Docket Item # 9
BAR CASE #2008-0060

BAR Meeting
May 21, 2008

ISSUE: Sign

LOCATION: 201 King Street

Figure 1 Facade

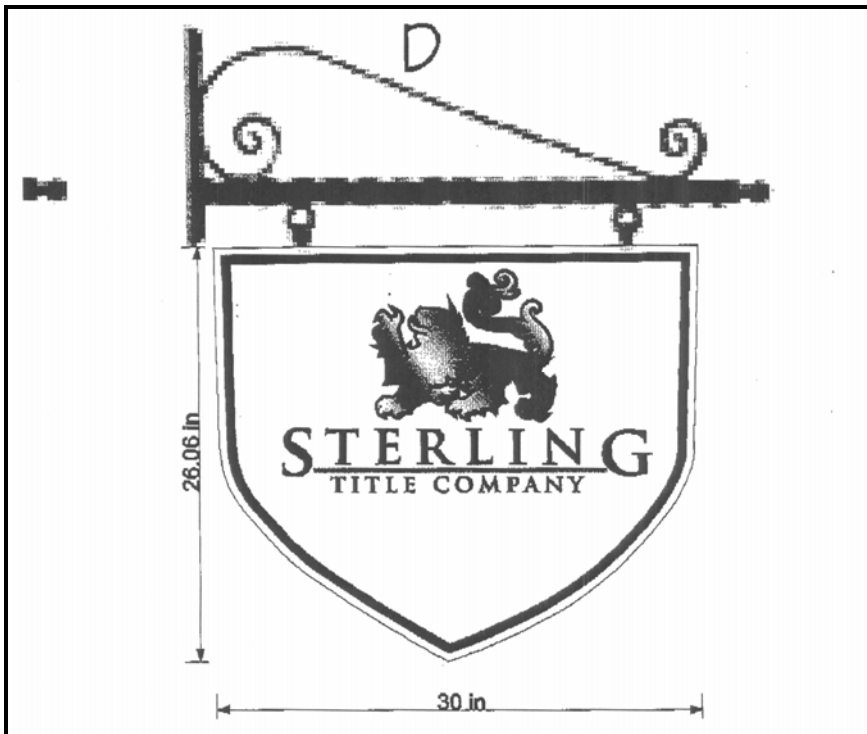
The applicant is requesting after-the-fact approval of a Certificate of Appropriateness for a hanging sign, STERLING TITLE COMPANY, at 201 King Street. The double-sided wood sign measures 26” by 30” and has black lettering on a white background. The sign includes the phone number of the business (1866-76-CLOSE) and an image of a lion. The sign was installed on a previously existing black metal sign bracket next to the main entrance along King Street.

The use of telephone numbers on signs in the historic districts is strongly discouraged by the *Design Guidelines*. Staff has no objection to the approval of the existing Sterling Title Company sign, provided the telephone number is removed.

IV. **STAFF RECOMMENDATION:** Staff recommends approval of the after-the-fact hanging sign for Sterling Title Company with the condition that the telephone number be removed.
